TO: Dr. Jesse Bacon, Superintendent
FROM: Danny Clemens, Director of Facilities
Date: February 21, 2024
RE: Baseball/Softball Fields -Change Order 15 - Bullitt East – Baseball/Softball Buildings, Batting Cage and Retaining Wall Modifications **DC**

Change Order

PROJECT: (Name and address)
BCPS - Phase II Athletics - Bid Package
No. 1 - Baseball and Softball
Bullitt County, Kentucky

CHANGE ORDER INFORMATION:
Change Order Number: 015

Revised Drawings: A1.51 and A1.52

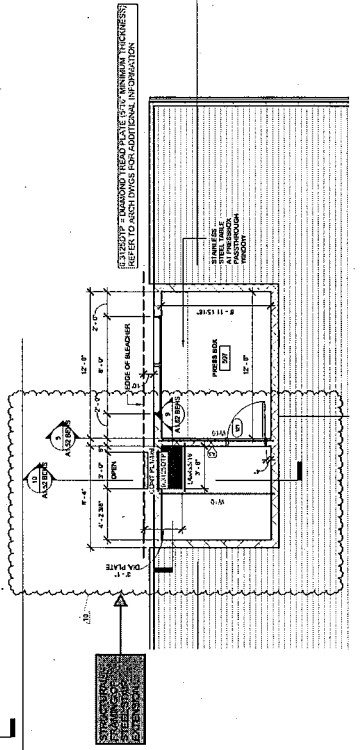
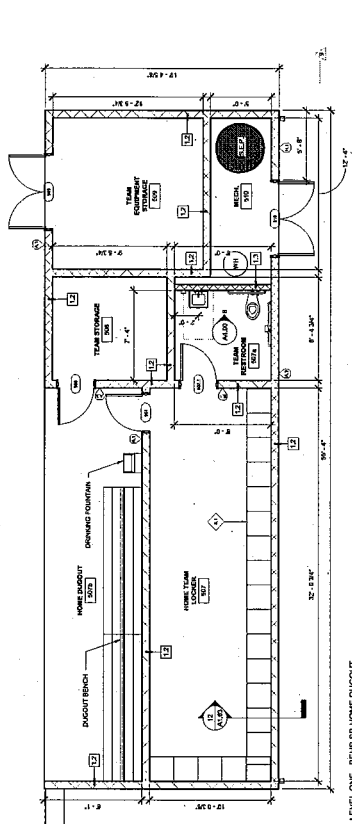
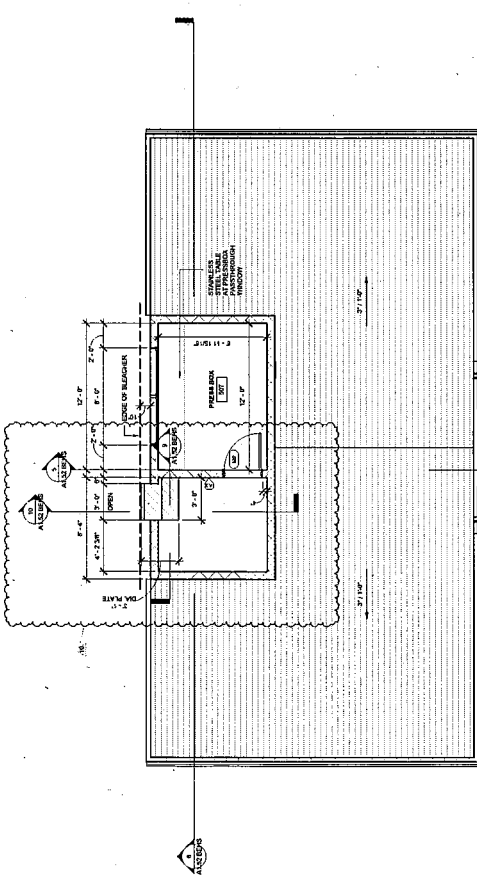
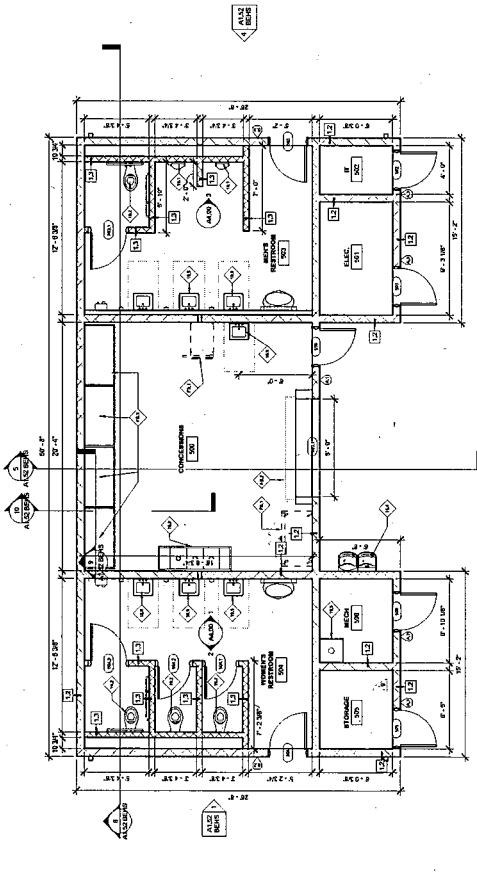
- Item No.1** Revisions as shown on revised drawings A1.51 and A1.52:
- See drawings for steel stair extension and steel framing revisions.

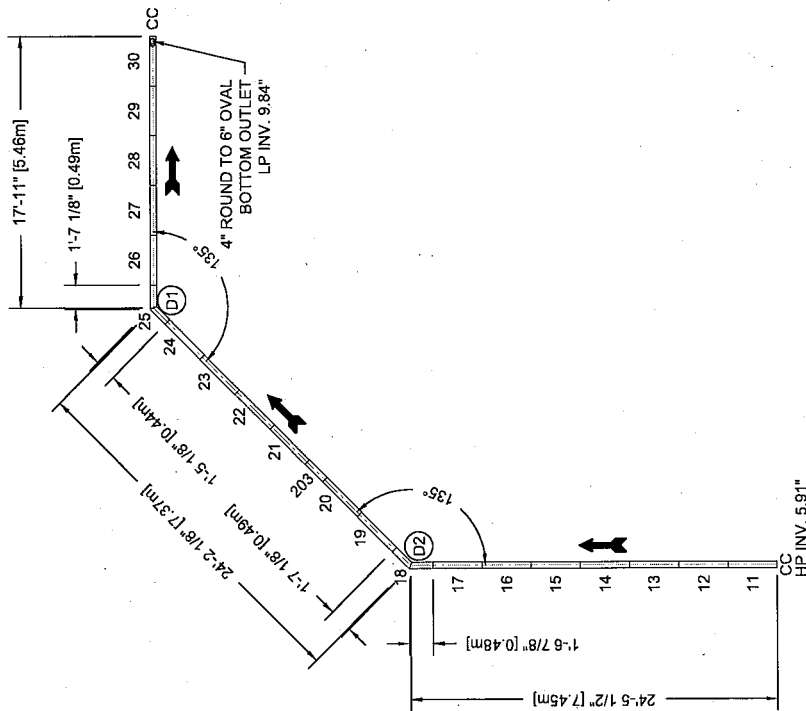
Installation of Trench Drain at Softball Field Bleacher Pads

- ADD 6" storm pipe, 25 LF = \$832
- ADD 12" storm pipe, 50 LF = \$2017
- ADD storm structures, 2/EA = \$4400 CCS Unit price Stormwater Manhole \$2,310/ea = \$4,620
- ADD DGA/grading, approx. 70 CY = \$3052 CCS Unit price stone \$46/CY = \$3,220
- ADD trench drain- provide material only = \$9315
